REGIS T. REPKO
Vice President
McGuire Nuclear Station

Subject: Duke Energy Carolinas, LLC (Duke Energy)
McGuire Nuclear Station, Units 1 and 2
Docket Numbers 50-369 and 50-370
Technical Specifications (TS) Sections:
3.3.2, Engineered Safety Feature Actuation System (ESFAS) Instrumentation
3.5.4, Refueling Water Storage Tank (RWST)
3.6.6, Containment Spray System (CSS)

License Amendment Request for Emergency Core Cooling System (ECCS)
Water Management Initiative

Figure 3.2.1-1

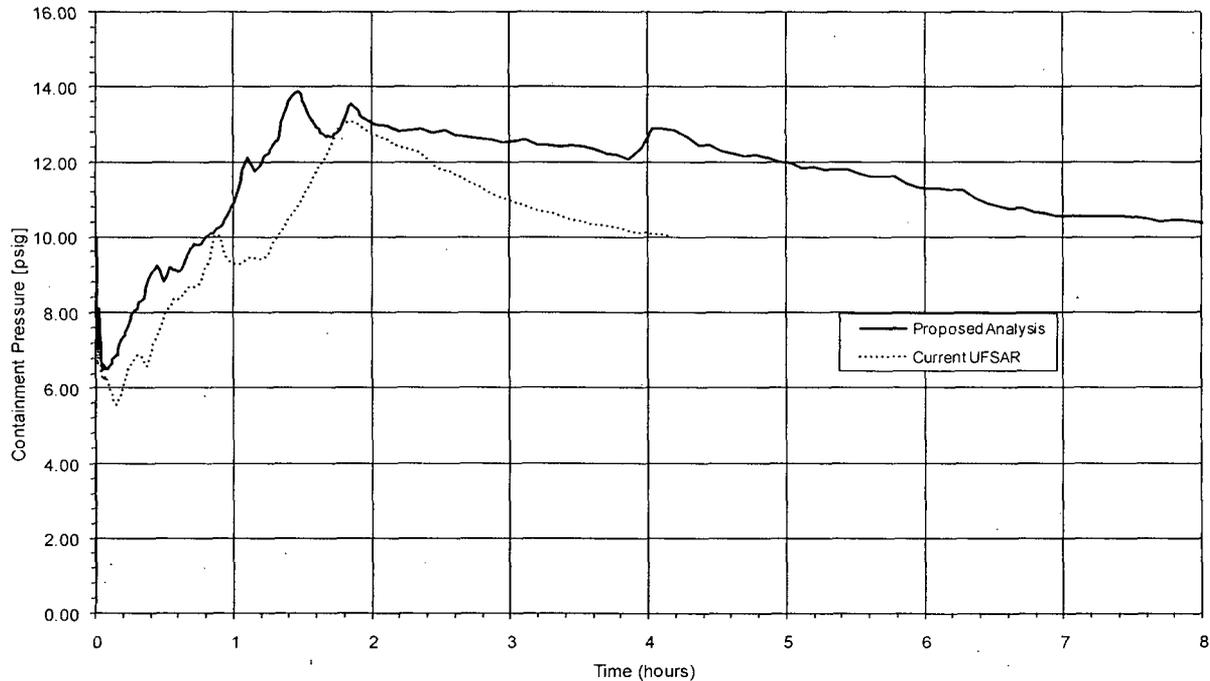
Two phenomena previously not included in McGuire peak containment pressure response analyses were observed. The first phenomenon, intact loop seal refilling, directly affects the containment pressure response. The current containment analysis diverts flow from the RHR pump from the cold legs and core cooling, to be used as auxiliary containment spray. The reanalysis keeps this flow aligned to the cold legs. For a cold leg break, the core steaming rate decreases with decay heat. The majority of the steam generated in the core passes through the broken loop and is released to containment. A fraction of this steam is drawn through the intact loops by the condensation of steam by cooler ECCS injection. Eventually the steam velocity in the intact legs decreases to the point where liquid spills over the reactor coolant pump weirs and refills the intact loop seals. At this point in time, all of the steam generated in the core exits the broken loop into containment to be condensed. In Figure 3.2.1-1 shown below, this occurs just before four (4) hours.

Figure 3.2.1-2

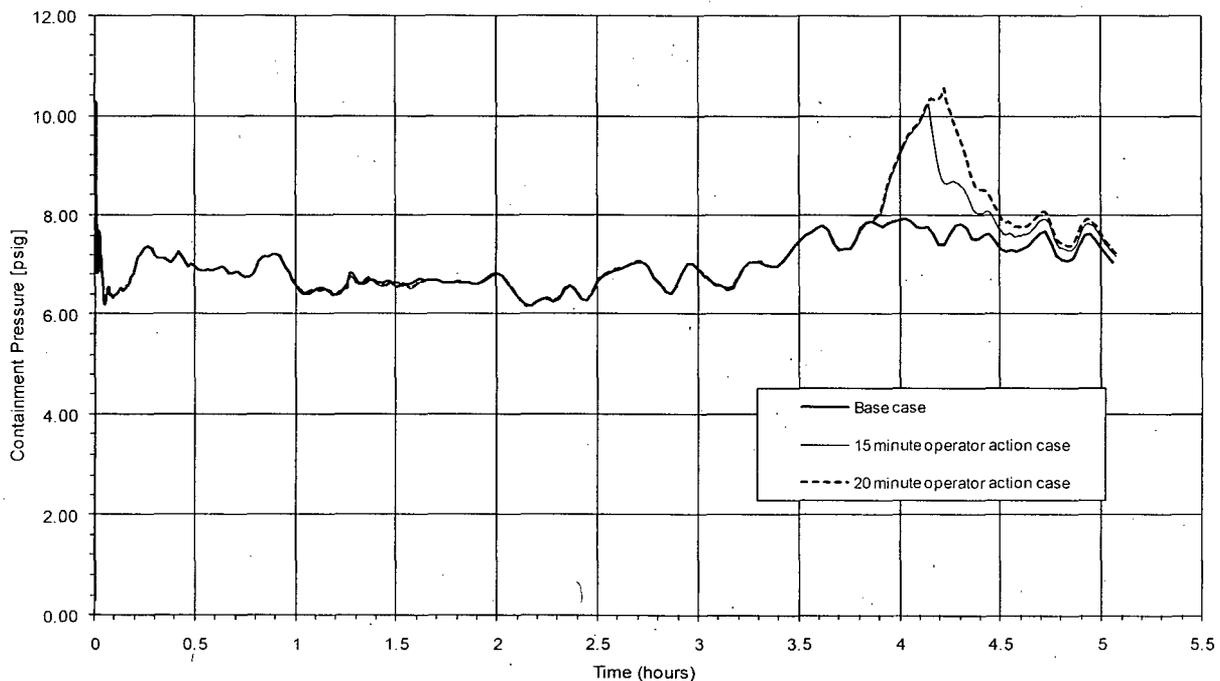
A sensitivity study has been performed to evaluate the containment pressure response to a CS Pump failure. The pump is assumed to fail at the time of peak pressure for the event. The results of this sensitivity study, shown on Figure 3.2.1-2, indicate that 20 minutes are available for operator action to initiate CS spray flow from the idle spray pump. If CS flow is initiated within 20 minutes, the peak containment pressure will remain below the containment design pressure. Operator action is reasonably achievable within the 20 minute timeframe.

Figure 3.2.7-1
McGuire LBLOCA Sump pH Response for Proposed Amendment

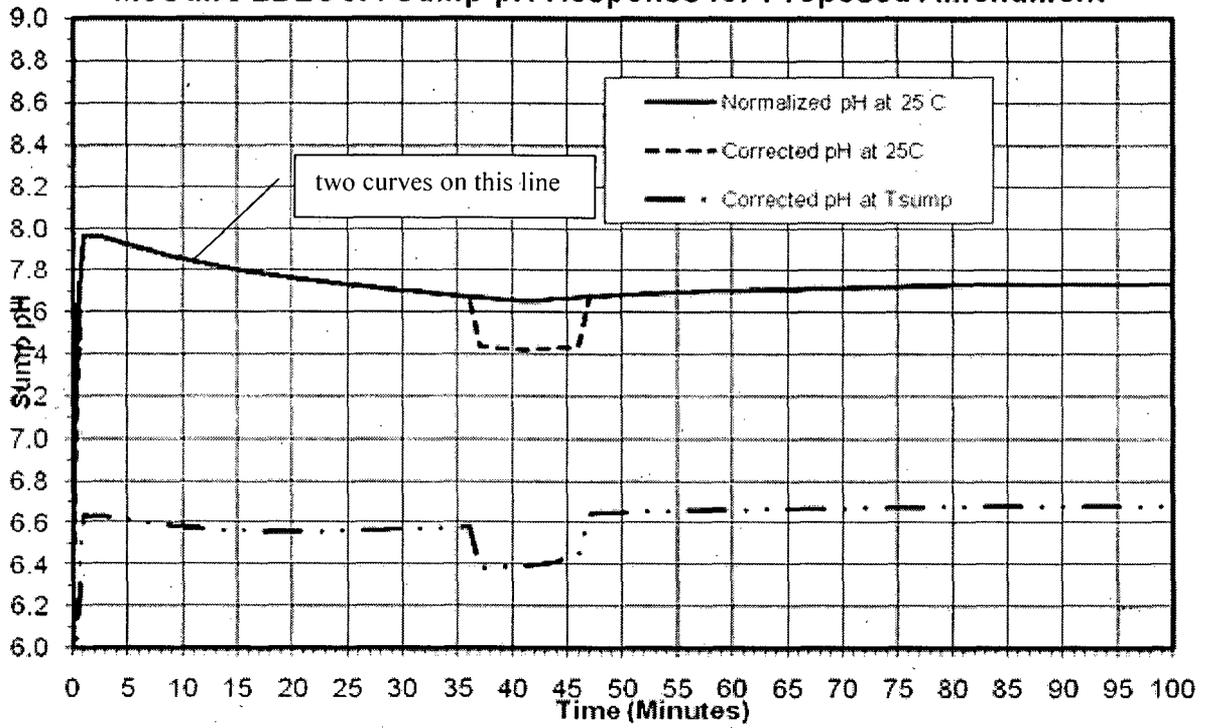
The CLB post-LOCA sump pH profile was provided in Reference 6. The proposed amendment post-LOCA sump pH profile is shown in Figure 3.2.7-1. This figure continues to show three curves: the corrected sump pH at the elevated sump temperature, the normalized sump pH at the standard temperature (25 °C), and the corrected sump pH at 25 °C. The "corrected pH at T_{sump} " curve continues to be used as the input to the spray lambda calculations. The description of this application and the justification for it supplied in Reference 7 continue to be valid for models associated with the proposed amendment.

Figure 3.2.7-2
McGuire LBLOCA Sump Concentrations

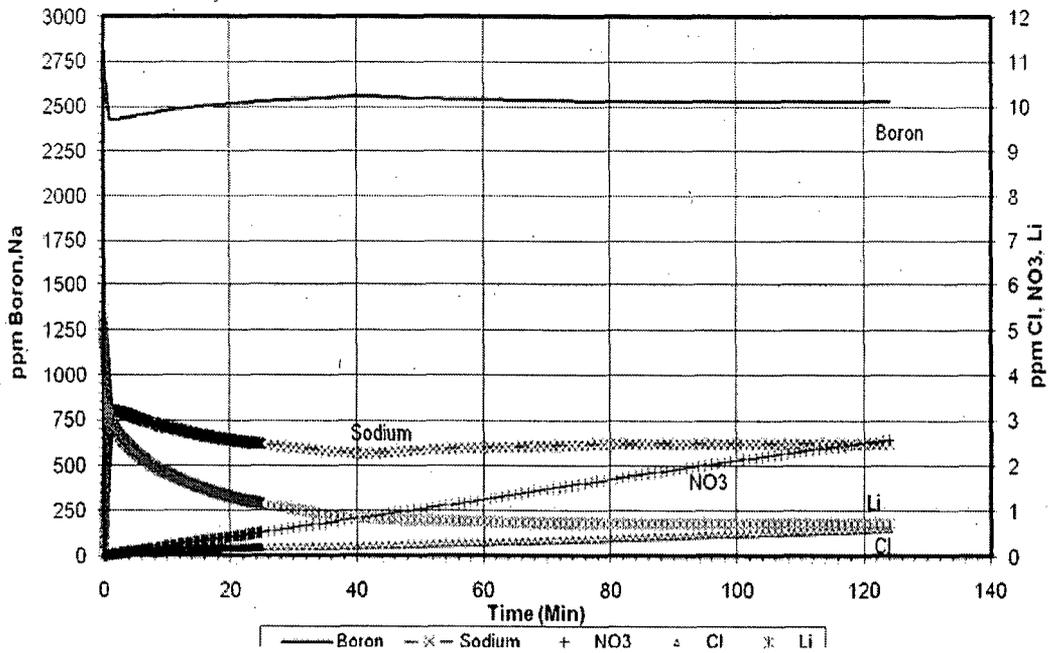
The ice condenser total ice melt mass is the same under the proposed amendment, but the time dependant profile of the ice melt is different. These profiles are compared in Table 3.2.7-2. There is no change to the cable insulation mass modeled or the types of cable insulation assumed. The conclusions in Reference 7 regarding the sensitivities of the sump pH model to these variables and regarding the variation in sump pH over the full 30 days (drawn from hand calculations) are not impacted by the proposed amendment. The concentration of the acids in the sump, under the amendment, is shown in Figure 3.2.7-2.
